DSP-13008

STAFF REPORT

SUBJECT: Detailed Site Plan DSP-13008
Type 2 Tree Conservation Plan TCP2-018-13
Gilpin Property

GILPIN PROPERTY

RENDERED LANDSCAPE PLAN

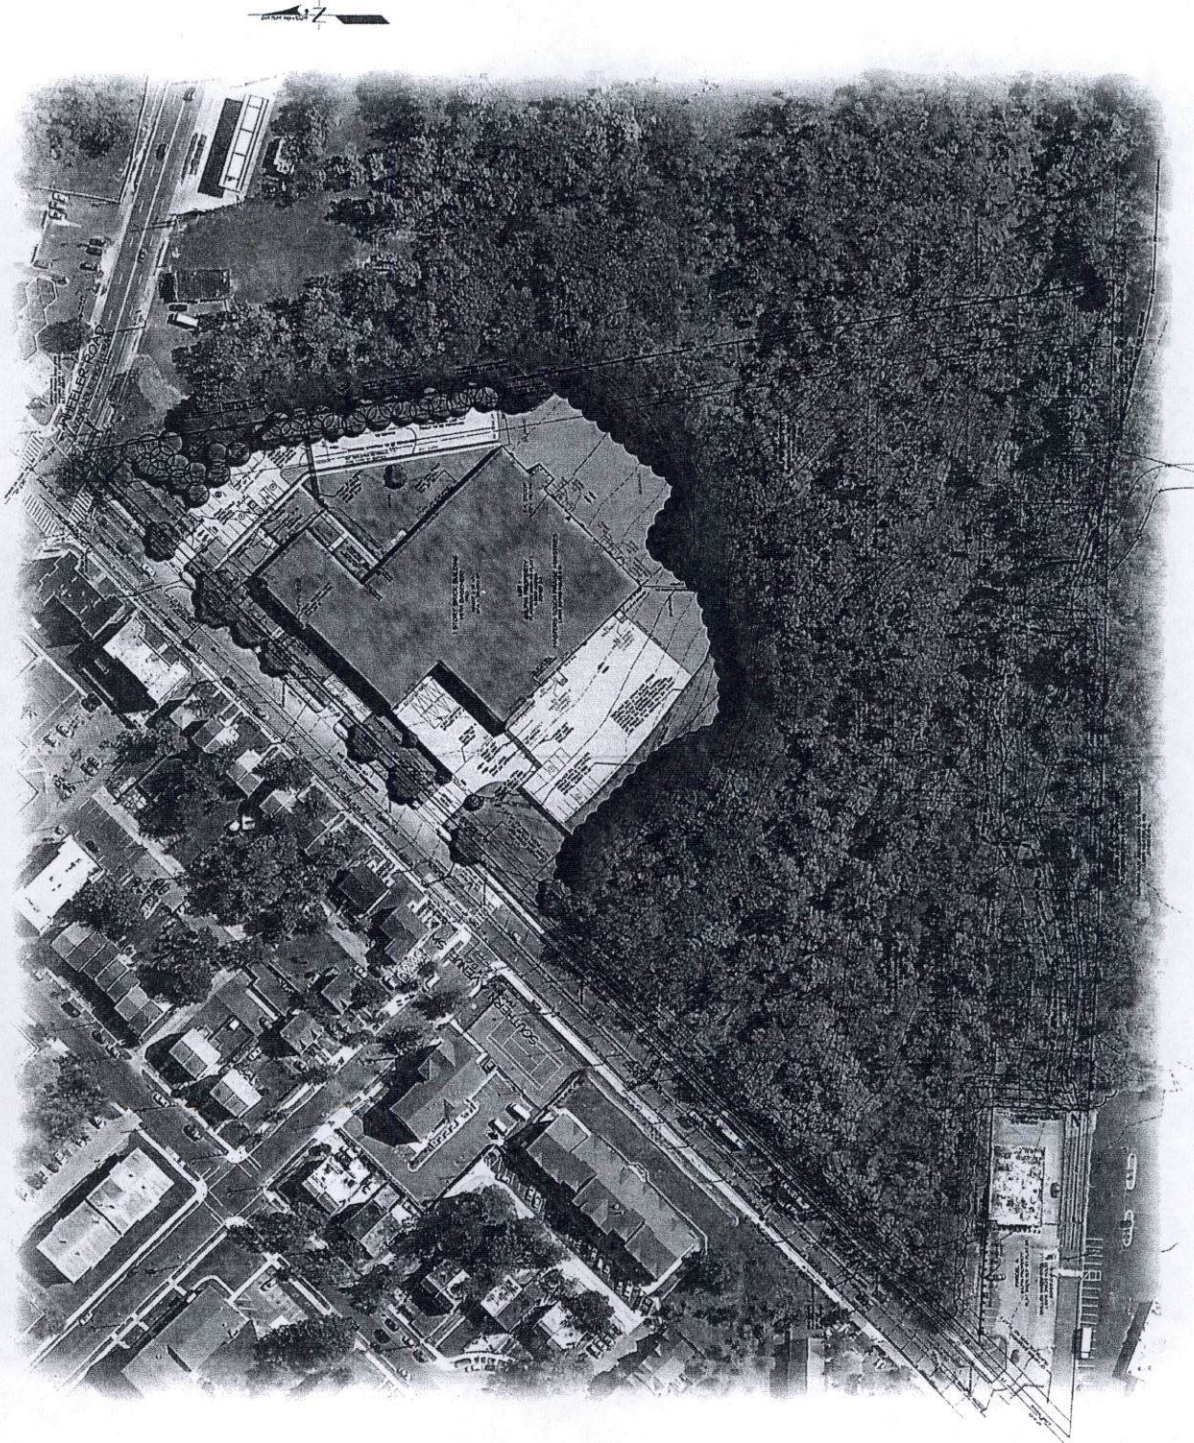
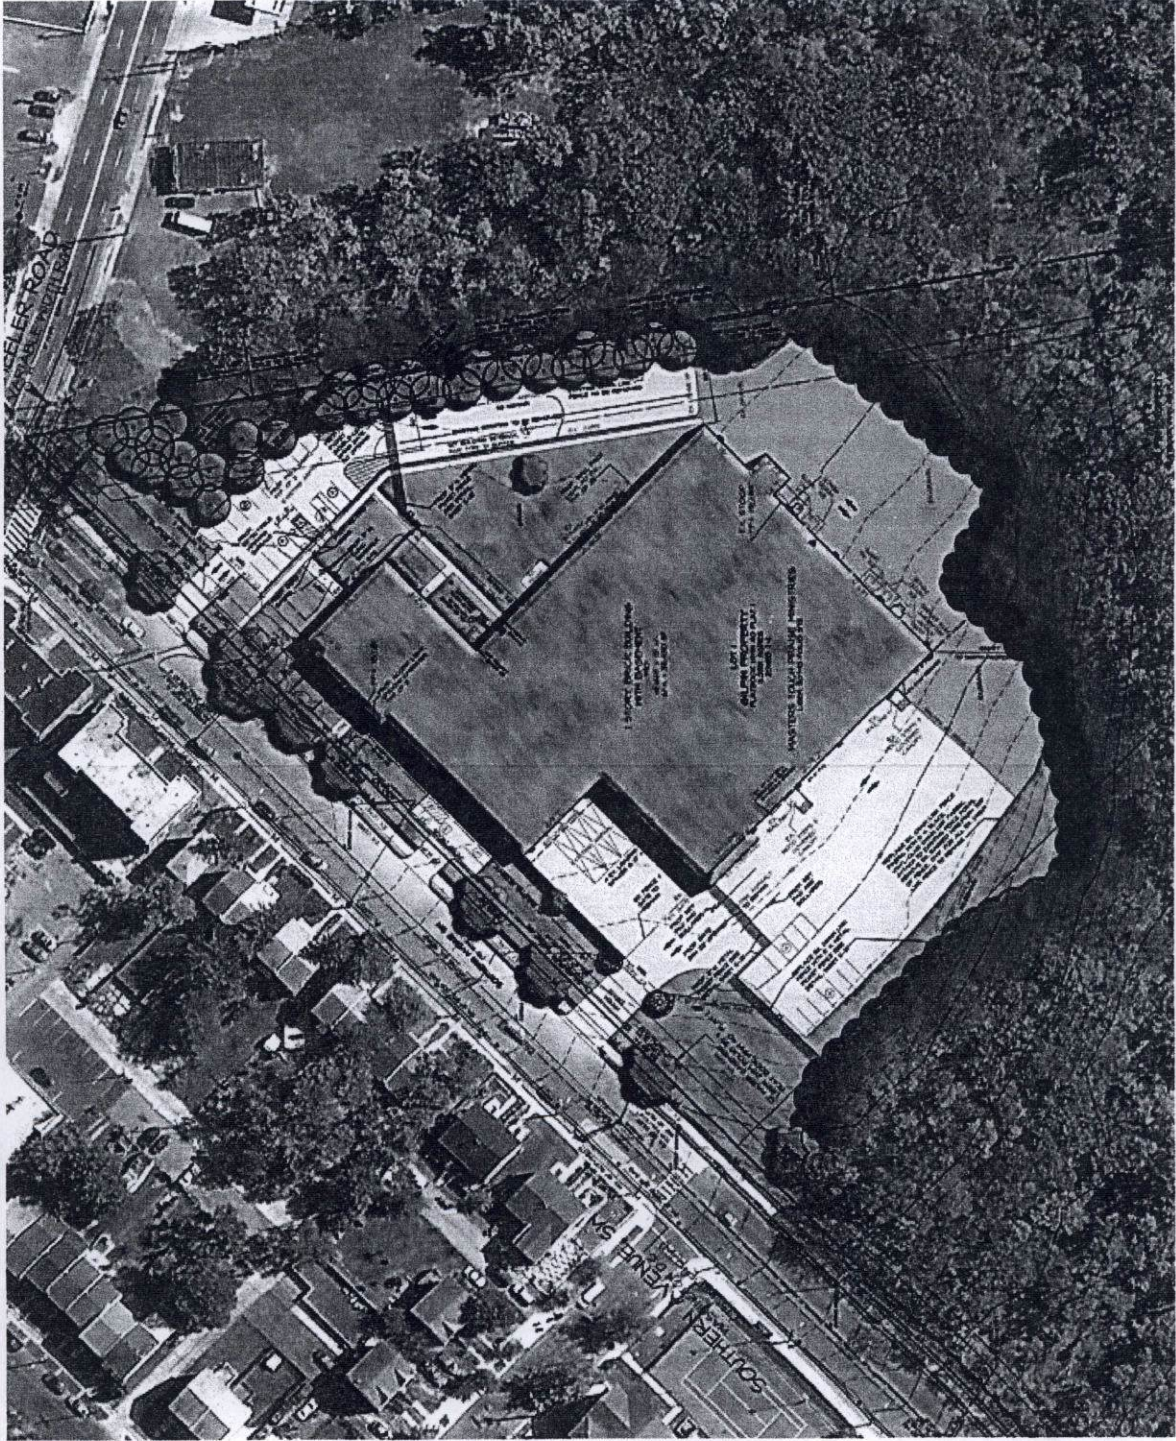
Once the parking lot is removed, two additional street trees should be provided as a continuation of the Southern Avenue streetscape. These plantings are subject to modification by the District of Columbia.

no structure; therefore, a 50 percent reduction is permitted. The applicant proposes to remove an area of existing parking and plant 31 shade trees along this property line, which will meet this requirement.

- e. A note shall be provided stating that "black-out windows along Southern Avenue shall not be permitted."
 - f. The three-space parking lot along Southern Avenue shall be removed and replaced with green area. Two additional street trees shall be provided near the removed driveway as a continuation of the streetscape, subject to modification by the District of Columbia.

ARCHITECTURAL ELEVATIONS

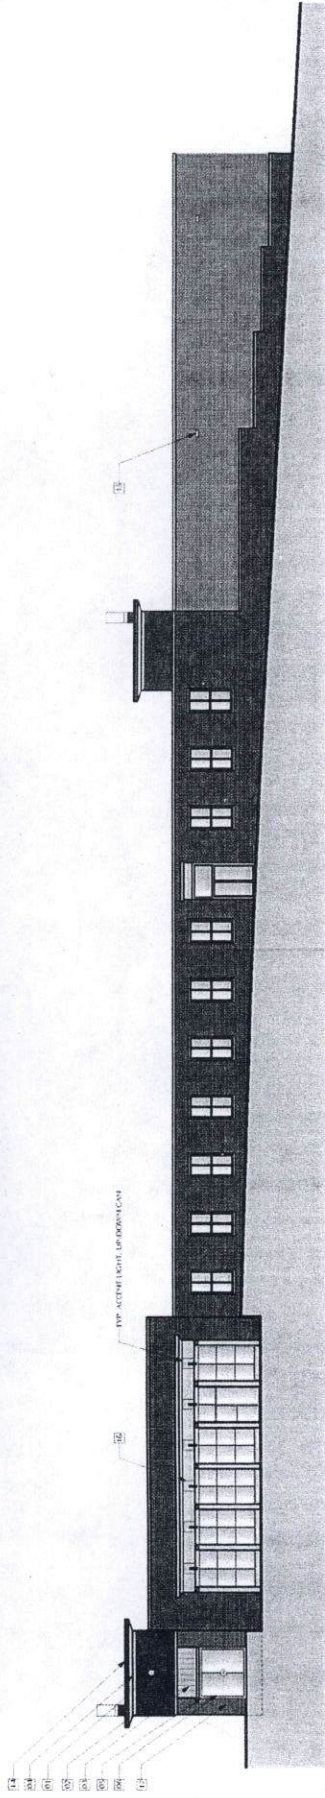
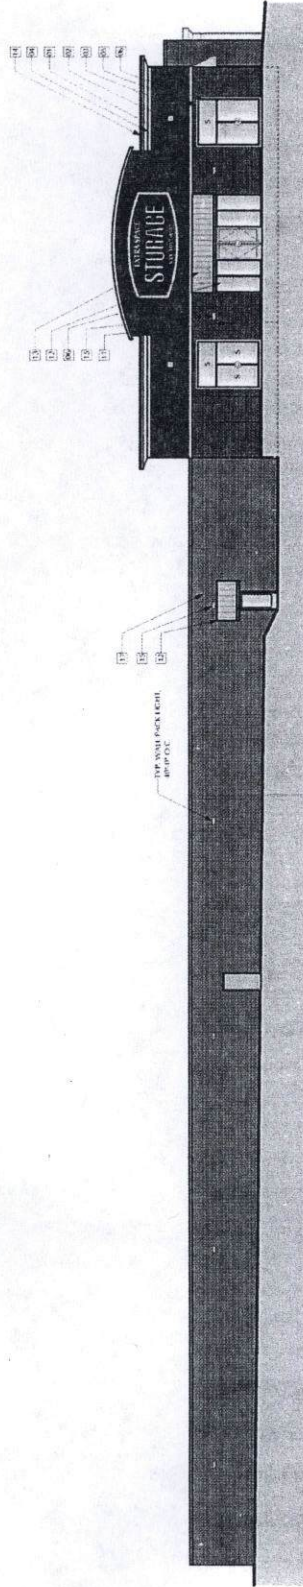
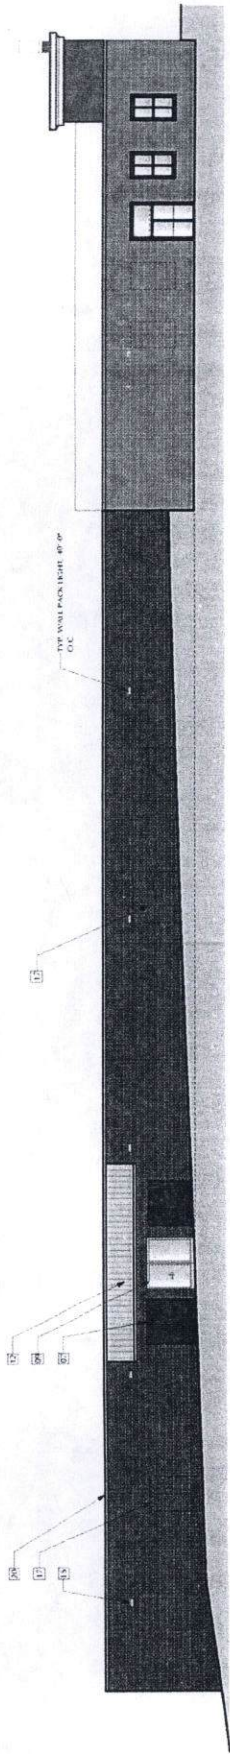
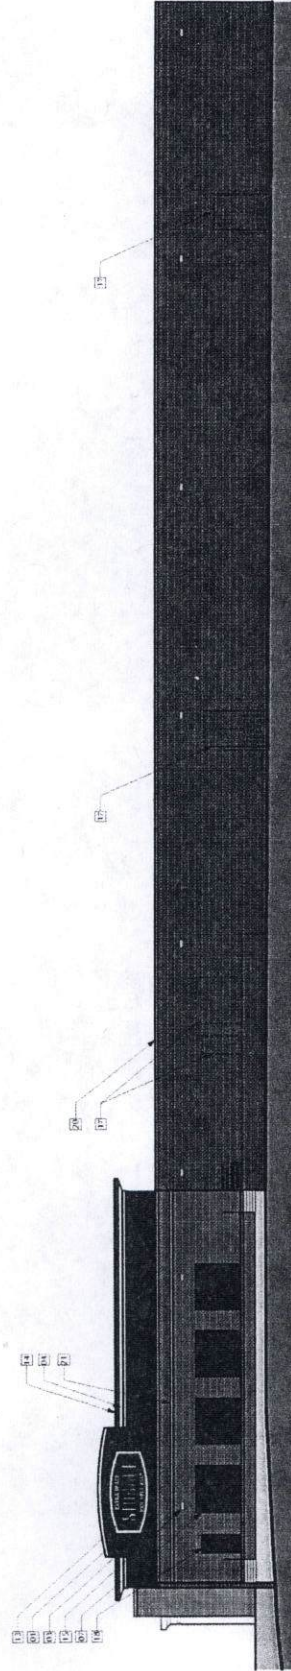
The primary building entrance for the self-storage business will be along the northeastern building elevation. In this area the building will be modified to provide glass doors and windows with tan, metal awnings above. A parapet wall is proposed along this elevation to increase the height of the building in the area of this primary entrance. A 10-17-foot-tall-parapet wall above the existing roof is proposed. This wall will be clad with green exterior insulation finishing system (EIFS) with a white cornice treatment. A secondary building-mounted sign is proposed along the southwest building elevation where a band of green EIFS and white cap flashing is proposed along the top of the existing building.

Other building modifications include removing stairs, existing doors and windows, and in some locations adding doors. The proposed brick used to infill the existing window and door openings should match the existing brick building. Notes to this effect should be placed on the architectural elevations. The service doors and loading doors are proposed to be painted green to match the signage. This could draw attention to the loading area from the right-of-way. These doors should be painted in a more neutral color compatible with the brick building. The front building elevation facing Southern Avenue will remain largely unaltered with the exception of the northeast corner of this elevation where a metal awning is proposed and a portion of the green EIFS parapet feature is continued.

Comment: The architectural elevations indicate that no entrances to individual units are visible from any street or from adjoining land in any residential or commercial zone.

1. Prior to certificate of approval of the detailed site plan (DSP), the following revisions shall be made, or information shall be provided:
 - a. A note shall be provided to indicate that the brick proposed to infill the existing windows and doors shall match the existing brick building.

- b. The service and loading doors shall be painted in a neutral color compatible with the brick building.
 - c. The location and square footage of the office shall be indicated on the detailed site plan.

1 First Floor Plan
A-100
Scale: 1/16" = 1'-0"

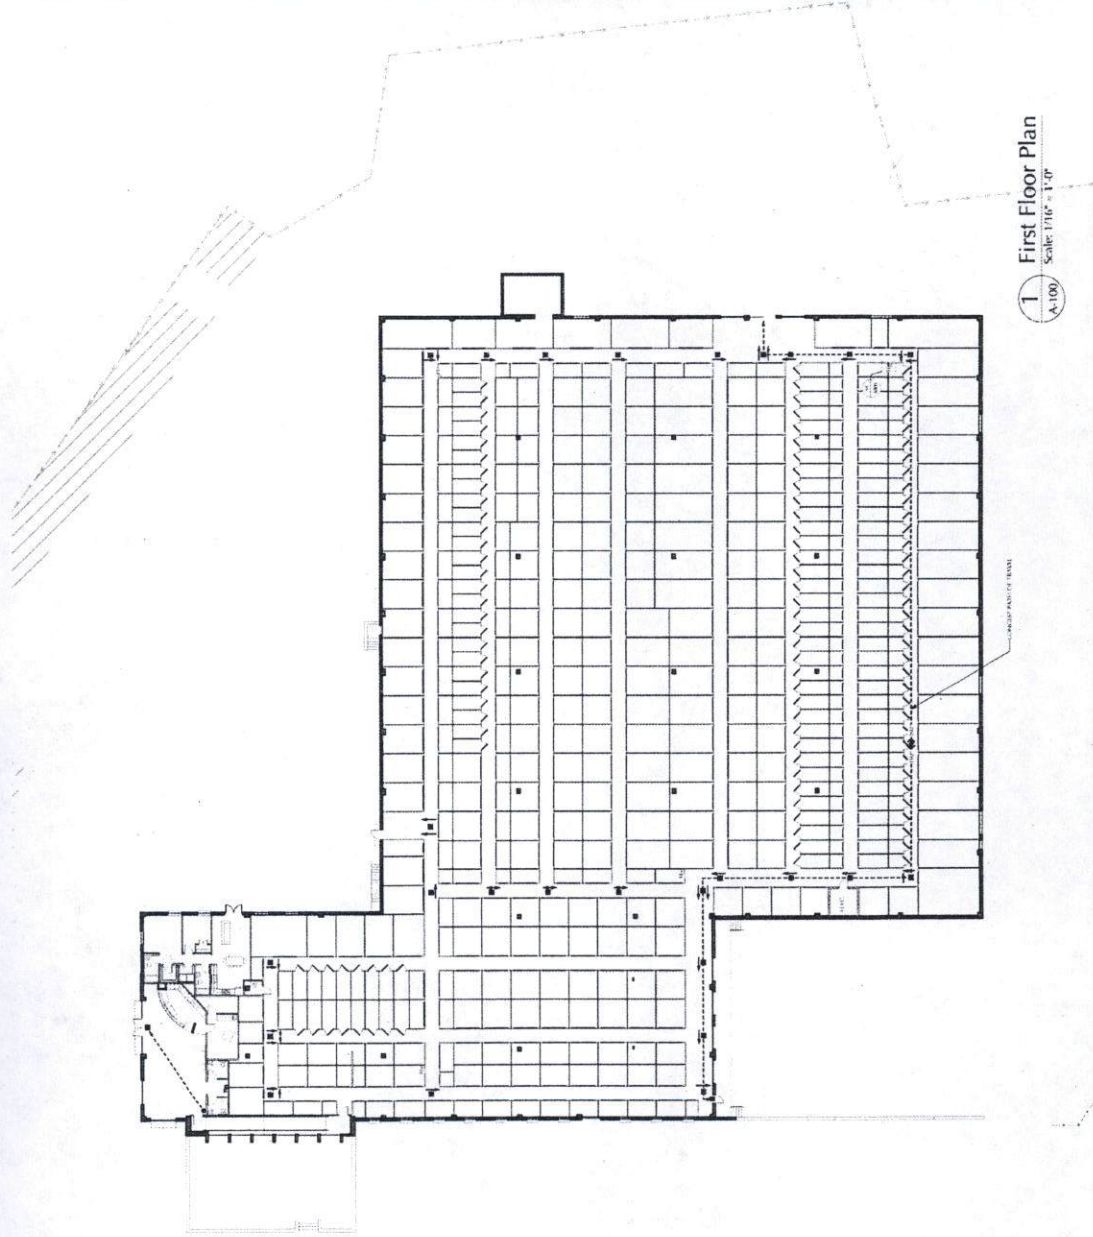
The provided floor plans indicate the layout of the interior access units and the office. The office is proposed within the northeastern side of the building at the proposed primary entrance. The location and square footage for the office component of the building should be indicated on the detailed site plan. Beyond the office and break room space for the employees are the storage units. The storage units will vary in size, and the units, along with the corridors accessing them, are indicated to fill the bulk of the warehouse space. The units are indicated to line most of the interior walls including many of the walls and windows fronting Southern Avenue. The project architect has indicated that a black screen or film will likely be utilized to make the windows and door along Southern Avenue fully opaque, so that there will be no views into individual units. Staff recommends that the interior layout be modified so a hallway or corridor is designed along the Southern Avenue elevation, allowing the windows to remain transparent. Blacked-out windows along Southern Avenue should not be permitted. Maintaining transparent windows is a feature of natural surveillance and a principle of Crime Prevention through Environmental Design (CPTED) that should be encouraged.

- d. The interior layout of the storage units shall be modified so a hallway or corridor is provided along the interior of the Southern Avenue elevation, allowing transparent windows.
